Service Bulletin

Model : Finisher D1

No.: Acc-149
(FF-T01-W-000056-01)

Subject : CORRECTING MISALIGNMENT (DURING SORTING)

Fig. 1

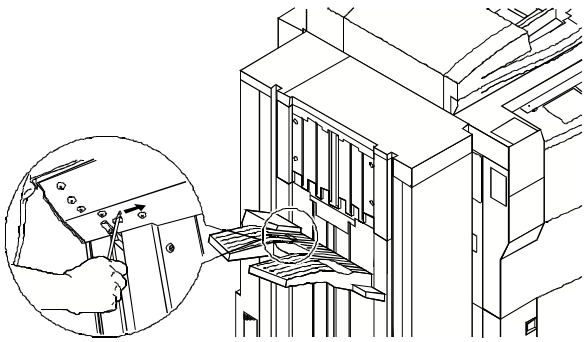
Servicing : < Making Checks and Making Adjustments >
1) If the delivery outlet tray is in the way, change its position.

Fig. 2

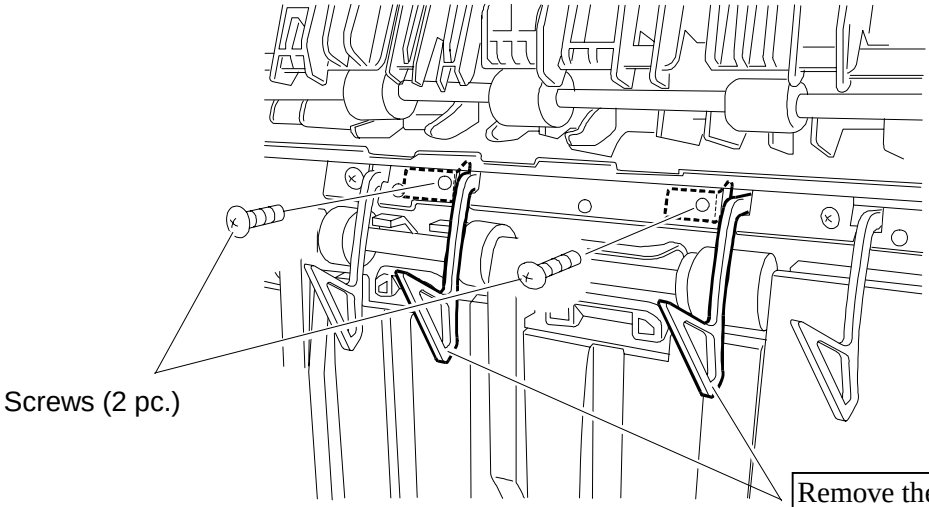
2) While holding up the swing guide, remove the inner two of the four screws. At this time, take care not to drop the screws inside the machine.
3) Of the four trailing edge arms, remove the inner two from the front of the finisher.

<Factory measure>
Remove two trailing edge arms to reduce the weight imposed on paper. (Remove the inner two of the four arms.)
